PETITIONER'S APPLICATION – ARLINGTON HEIGHTS PLAN COMMISSION	
Petition #: P.C. _____	P.I.N.# <u>03-08-103-004-0000</u>
Petitioner: <u>Hillside Auto Body &amp; Service, Inc.</u> <u>120 W. University Drive</u> <u>Arlington Heights, IL 60004</u>	Location: <u>25 E. University Drive</u> Rezoning: <u>X</u> Current: <u>M1</u> Proposed: <u>M-1</u> Subdivision: <u>N/A</u>
Owner: <u>University Drive Acquisitions, LLC</u> <u>25 E. University Drive</u> <u>Arlington Heights, IL 60004</u>	# of Lots: <u>    </u> Current: <u>    </u> Proposed: <u>    </u> PUD: <u>    </u> For: <u>    </u> Special Use: <u>    </u> For: <u>    </u>
Contact Person: <u>Mark Balek</u> Address: <u>120 W. University Drive</u> <u>Arlington Heights, IL 60004</u>	Land Use Variation: <u>X</u> For: <u>Major Repair in</u> <u>M-1 district.</u> Land Use: <u>    </u> Current: <u>    </u> Proposed: <u>    </u>
Phone: <u>(847) 253-0183</u> Fax #: <u>(847) 253-1658</u> E-Mail: <u>markb@hillside towing.net</u>	Site Gross Area: <u>15,110</u> square feet # of Units Total: <u>Not applicable</u> 1BR: <u>    </u> 2BR: <u>    </u> 3BR: <u>    </u> 4BR: <u>    </u>

# MEMORANDUM

**RE:** Hillside Towing  
25 E. University  
PC#15-004

**Re:

## ALTA/ACSM LAND TITLE SURVEY

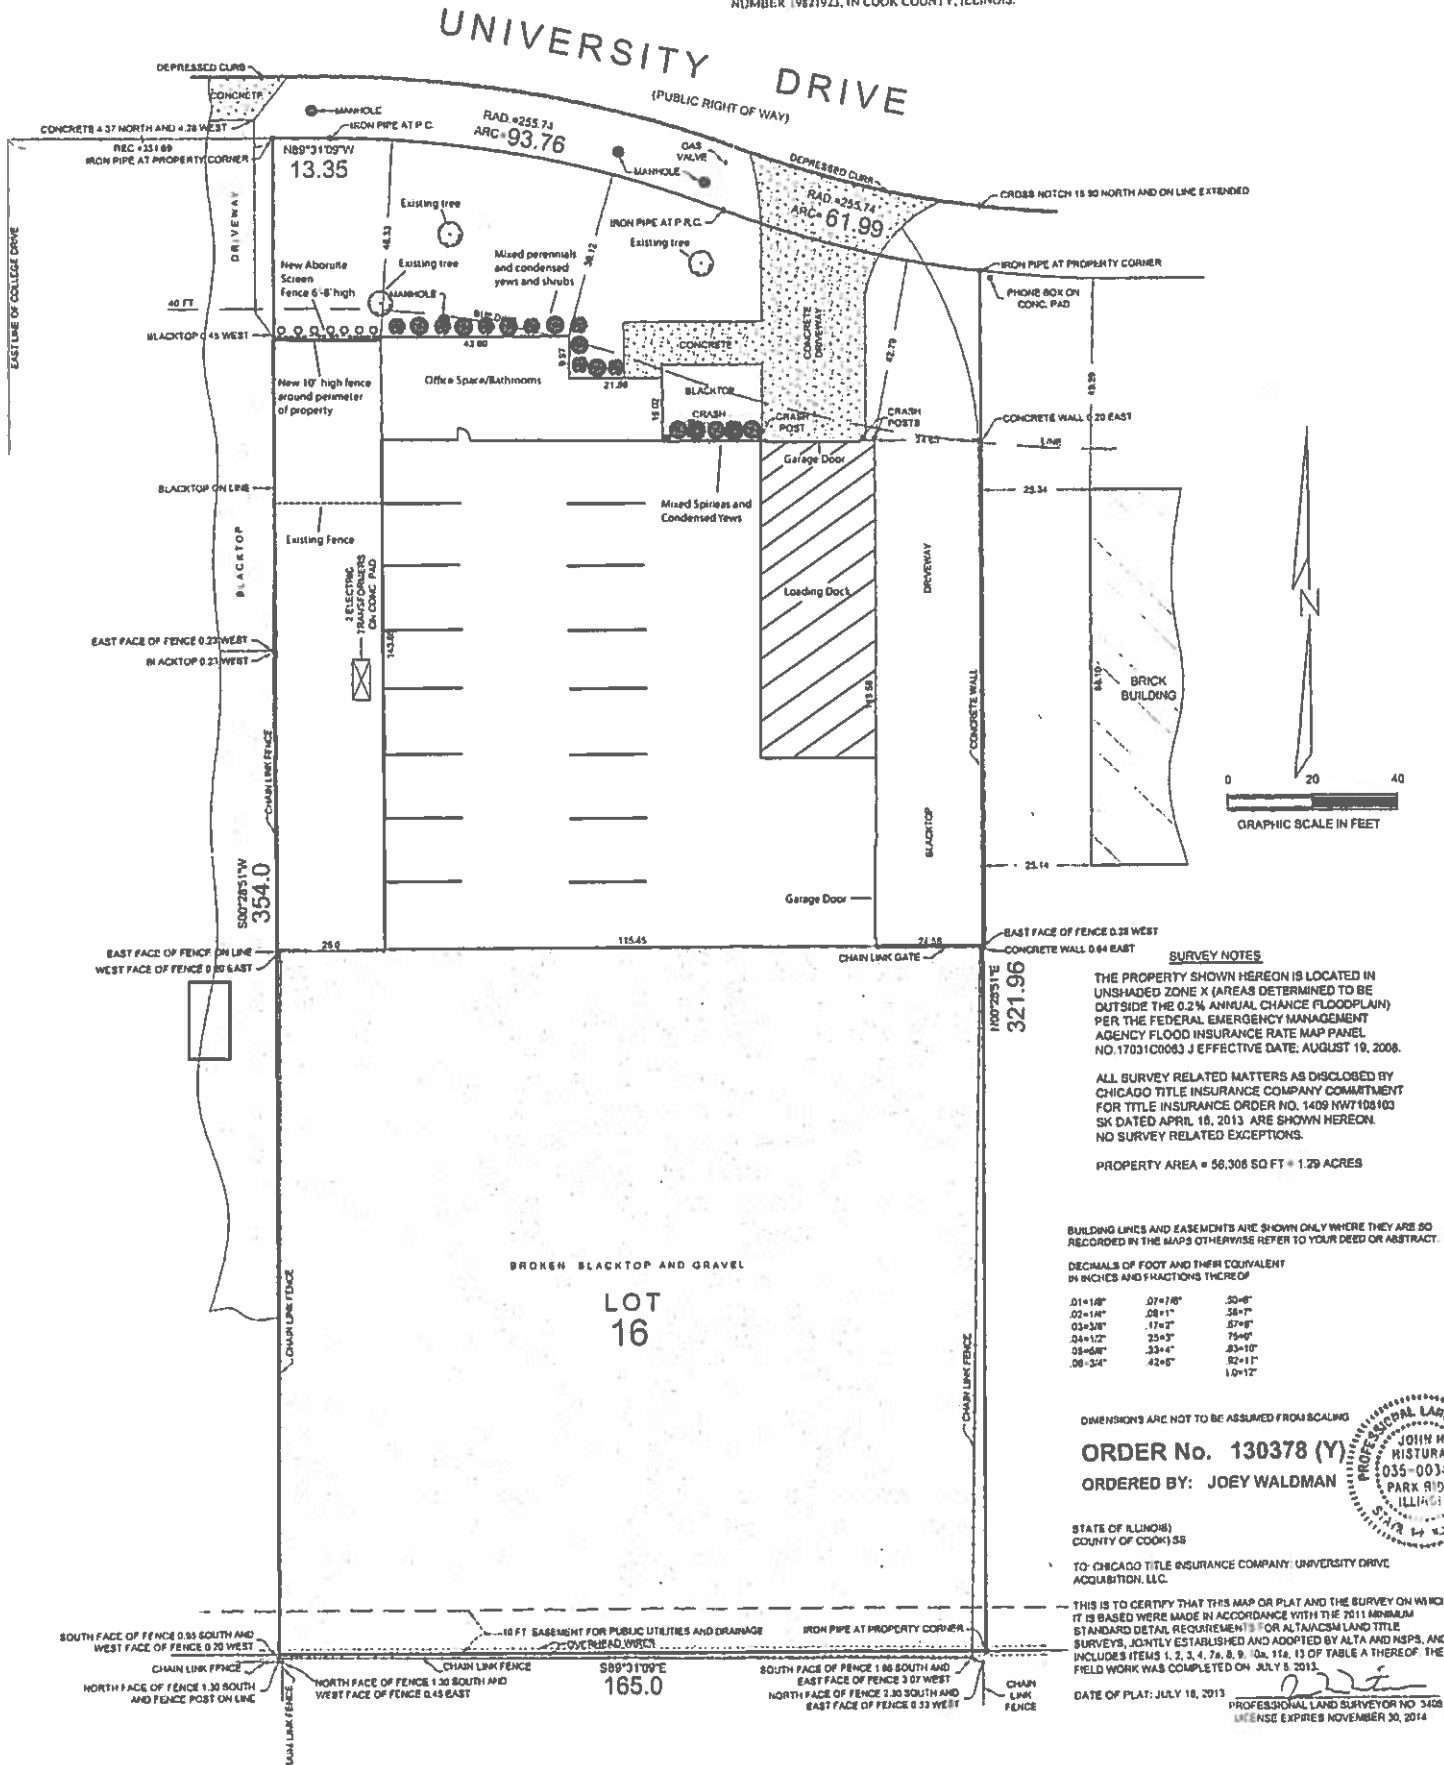
10. Per the Plat of Survey provided, the rear yard is broken blacktop and asphalt. Per Chapter 28, Section 11.2-12.2, all off-street parking areas shall be improved with a compacted base, surfaced with asphaltic concrete or comparable all-weather dustless material of a design and thickness in accordance with prescribed engineering standards.

21. The required front yard setback for a property in the M-1 district is 40 feet. From the Plat of Survey provided, the front yard setback is 39.12 feet. This is considered existing non-confirming. No action is needed.

*Response:* The enclosed storage lot is paved asphalt with some broken blacktop. Petitioner withdraws its previously proposed parking options. The storage lot will not be open to customers or the general public. *See* Petitioner's Revised Plan. Notwithstanding the foregoing, Petitioner, with Village approval and permits, will repair the pot holes and areas of broken asphalt.
